METROPOLITAN GOVERNMENT OF NASHVILLE AND DAVIDSON COUNTY

STAFF RECOMMENDATION
613 17th Avenue North (MLK, Jr Academic Magnet School)
August 19, 2015

Application: New construction-addition

Figure 1: Non-historic buildings to be demolished.

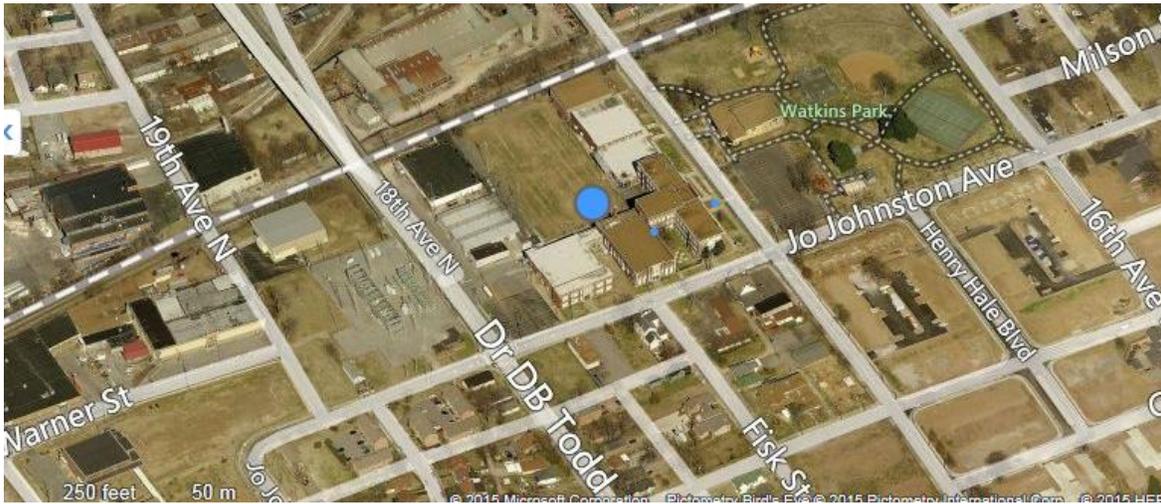
Demolition: The campus includes a concrete block building and a series of metal buildings that will be removed for a parking area and later phases of construction. These buildings are not historic and do not contribute to the historic character of the campus. Demolition meets section III of the design guidelines.

Figure 1: Shows the dates of construction for the MLK campus.

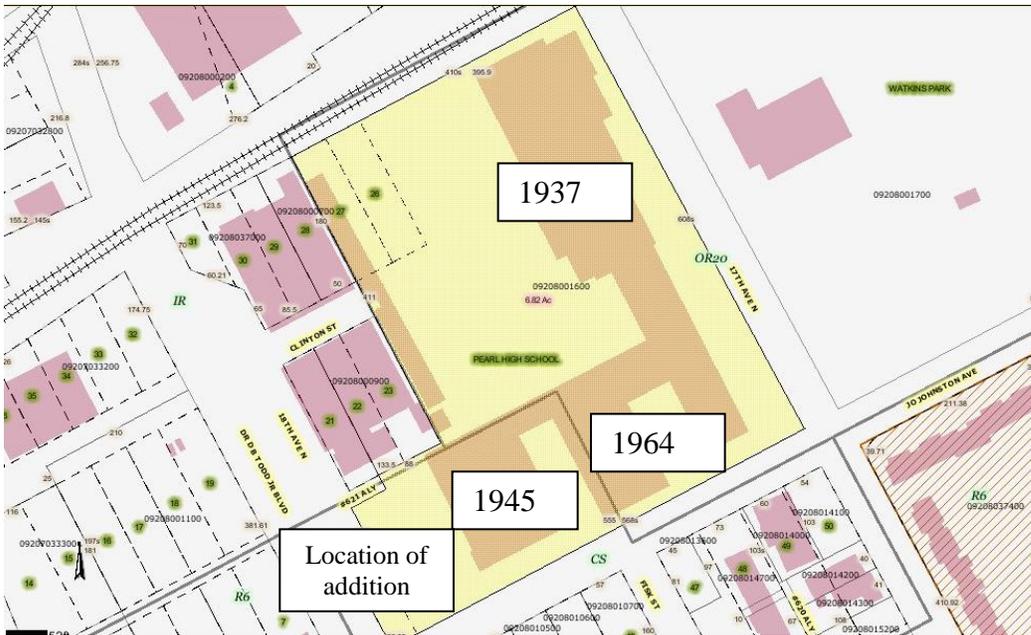
Building Site: The MLK, Jr. Academic Magnet High School is a local Historic Landmark. The primary historic 1937 portion of the campus faces 17th Avenue North. The proposed addition will be behind this portion with highly visible portions on Jo Johnston Avenue and Dr. DB Todd Jr. Blvd. (See figure 1.) It will be attached to the rear/side portion of the 1945 addition. (See figure 2.)

The parking lot will be behind the historic buildings in the area of the non-contributing buildings, which meets the design guidelines. The project includes slight reorientation of Eighteenth Avenue North and Dr. DB Todd Blvd, which MHZC staff signed-off on administratively.

Figure 2: Addition will be attached to the left of the dashed line.

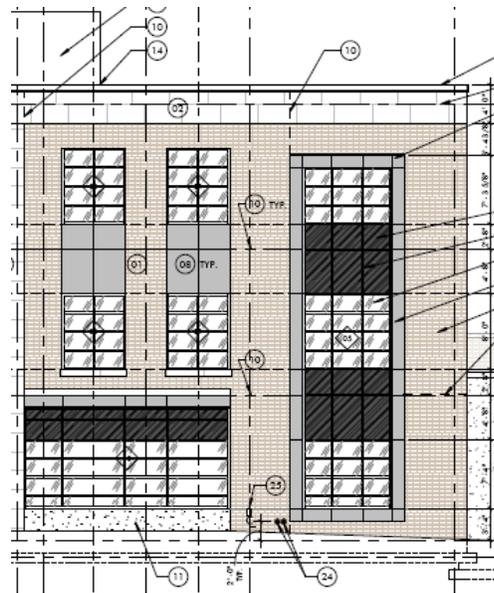
The proposed addition does not alter or remove significant features of the site. The location keeps the addition from detracting from the historic portions of the campus. There are no known archaeological areas in this heavily disturbed area. For these reasons, Staff finds the project to meet section II of the design guidelines.

Figures 1 and 2: The corner bays of the historic building (left image) have wide windows as seen on the first floor of the addition, right image.

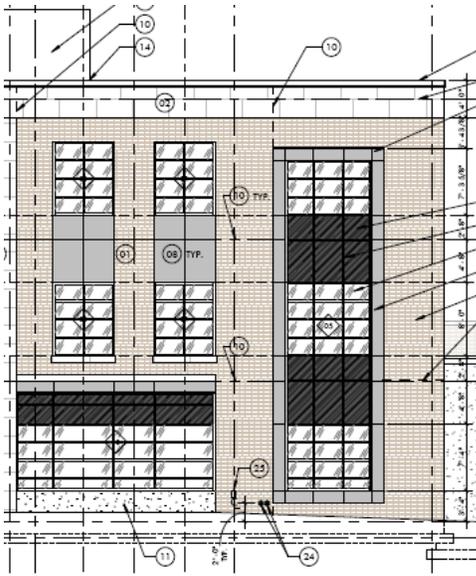
Compatibility of Openings: The rhythm of openings includes wide areas of glazing on the ground floor and narrower columns of glazing on the upper levels that span floor lines in a similar manner to the earliest building on the campus.

Figures 3 and 4: The columns of windows on the upper levels of the addition are a modern interpretation of columns of windows on the masonry bays of the historic building which sometimes span floor levels.

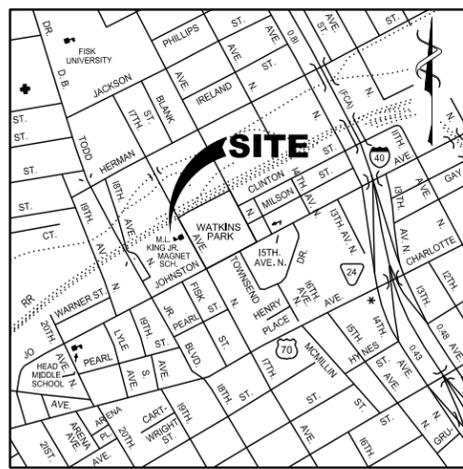
Compatibility of Materials: Materials for the siding include brick, calcium silicate masonry units, architectural exposed concrete and metal panels. The masonry products are similar to the materials used on the historic building and provide for a modern interpretation the simple brick and stone. Staff recommends final review of the masonry and the metal panel colors. Windows and their components include aluminum storefronts, metal panel rain screens, spandrel glass at the floor lines, and painted aluminum curtain wall. Staff recommends final review of masonry design, dimensions and color and metal colors.

Staff recommends approval with the conditions that staff provide final approval of masonry design, dimensions and color and metal colors and that the applicant return with a new design for the Jo Johnston (south) building façade in a subsequent phase. With these conditions, the project meets the design guidelines for new construction on a Landmark site.

WEST BUILDING ELEVATION
(FACING DR. D.B. TODD BLVD)

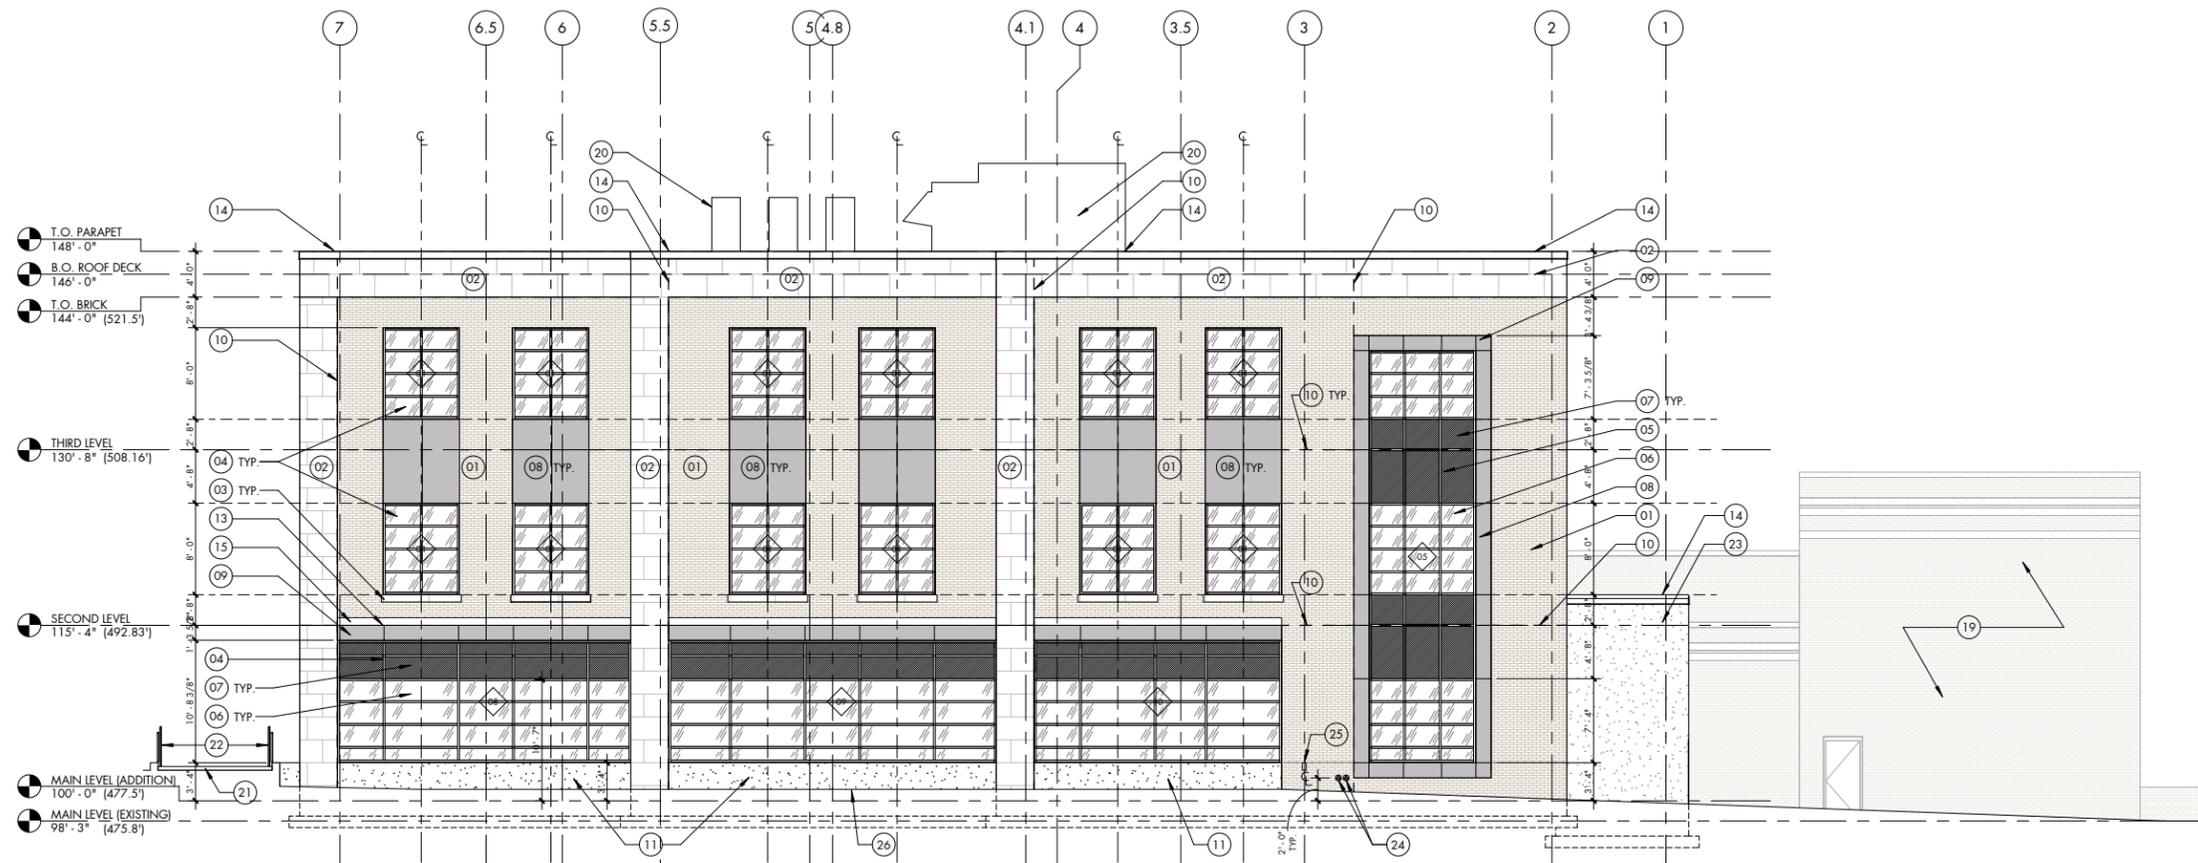
Compatibility of Massing & Form: The addition will be three-stories with a flat roof, similar to the historic portions of the campus. The façade facing Dr. DB Todd Blvd will not affect the historic character of the campus as it will not be seen in relationship to the original building nor will it physically touch this earliest building on campus. The Jo

SOUTH BUILDING ELEVATION
(FACING JO JOHNSTON AVE)

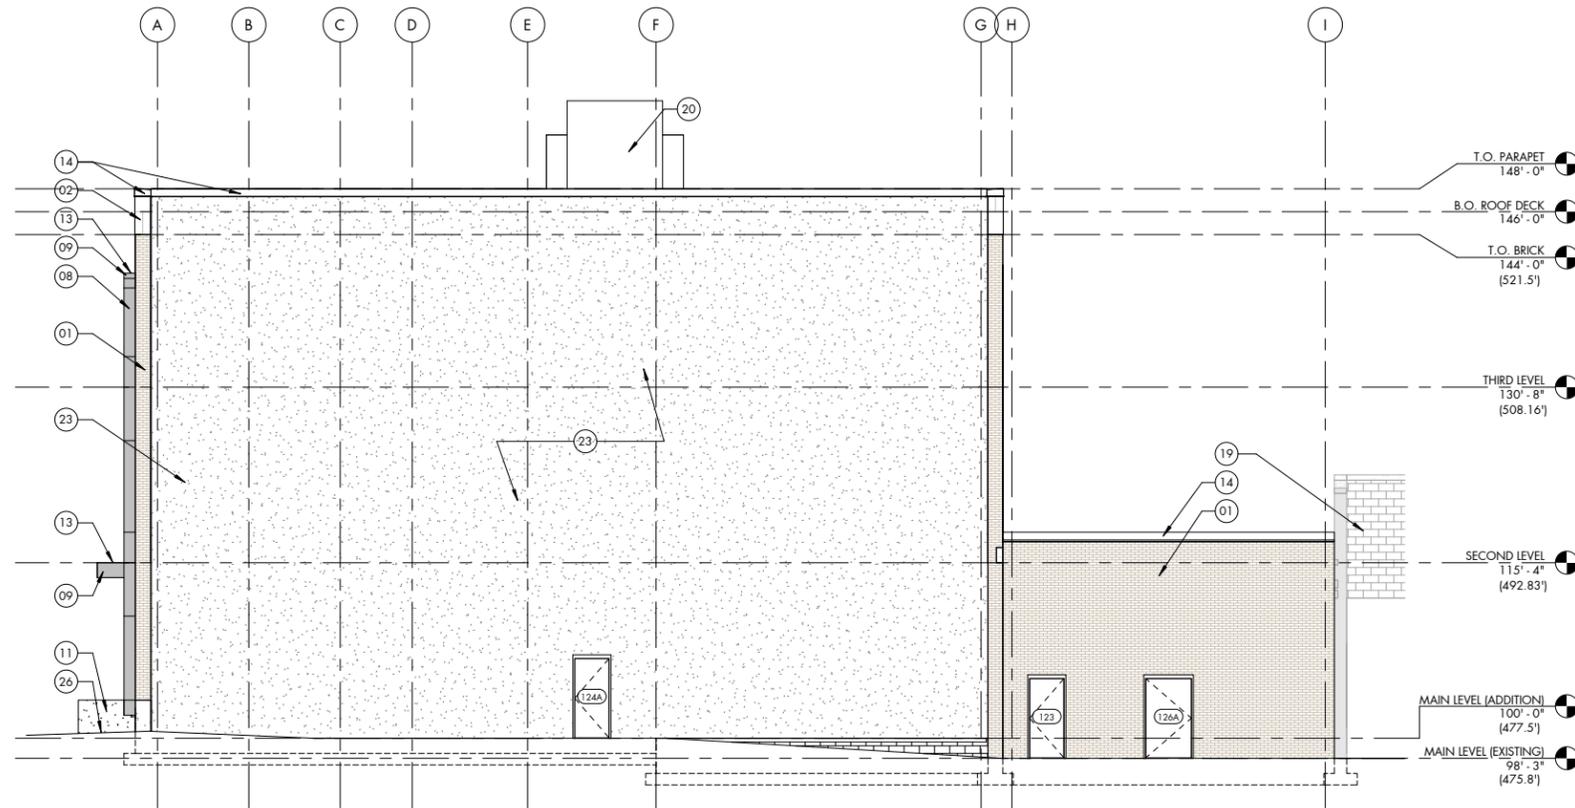
Johnston Ave façade will have an impact on the historic portion of the campus due to its proximity to the 1945 addition. Presently that façade is one large blank wall, which would not be considered appropriate; however, it is designed in this manner to accommodate a later phase that will include a new face with an addition that will bring it up to the current setback of the 1945 addition. The attachment will occur behind the first pile of the historic building. The applicant will return to the MHZC with the design of that new portion at a later date. The addition meets section 9 of the Secretary of Interior Standards.

Recommendation Summary: Staff recommends approval with the conditions that staff provide final approval of masonry design, dimensions and color and metal colors and that the applicant return with a new design for the Jo Johnston (south) building façade in a subsequent phase. With these conditions, the project meets the design guidelines for new construction on a Landmark site.
